Responsible: D. Rutz  
Date: 20.12.2004

**NEW WATER COLLECTOR SET for all of the 60cm and 45cm models**

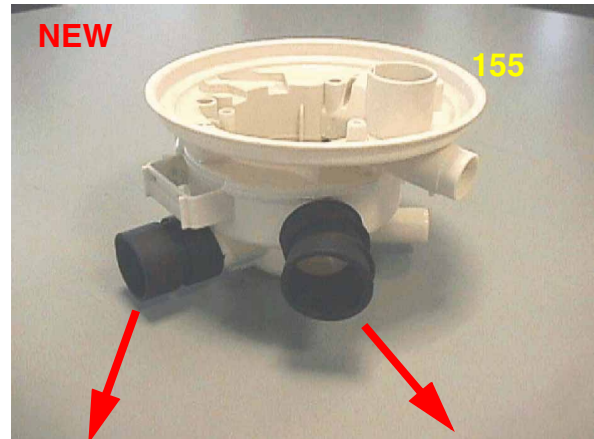
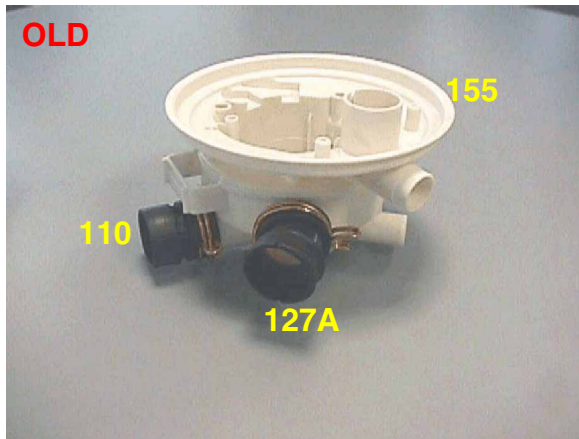
As of serial number 424 ... (June 2004) a new water collector set with fitted coupling sleeves has been installed in all of the new models of 60cm and 45cm dishwashers.

The spare-part no. of the modified part was changed on implementation of the new part.

The full new sets of water collectors can replace those used in appliances produced prior to modification, provided that the old hoses are removed and the discharge pump fastening clamp is used again.
